## Response to A/110/21/PL McCarthy & Stone development of Chandlers Site.

### Angmering Parish Council Response

Striding Massing Study Viewed from the East

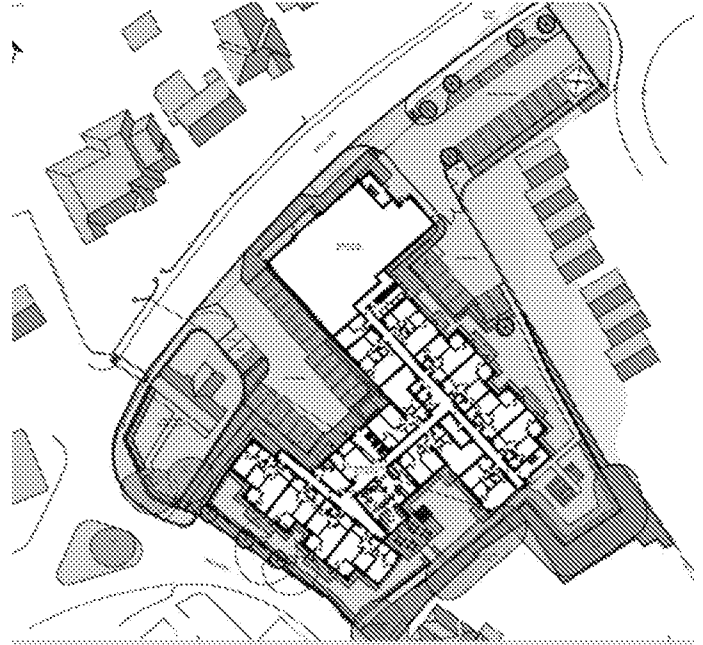
The density exceeds that of the surrounding area both in terms of number of dwellings and proportion of the site covered with buildings. The apartments are all two storey, albeit with high roof pitches which make the bulk of the buildings generally higher than surrounding dwellings. Ground levels to the rear (Cumberland Crescent) are higher which may mitigate this impact. However, the height of the building fronting onto High Street is particularly concerning given that this part of the site is in the Conservation Area and adjacent to a Grade II listed building 'Eachways', which the drawing below shows is much lower in profile.

The apartments have been designed to appear as terraces of individual houses rather than apartment blocks. The frontage onto High Street is more monolithic due to the single roof plane and restricted palette. Whilst the other elevations are less prominent, they will still be visible as demonstrated in the massing drawings above.
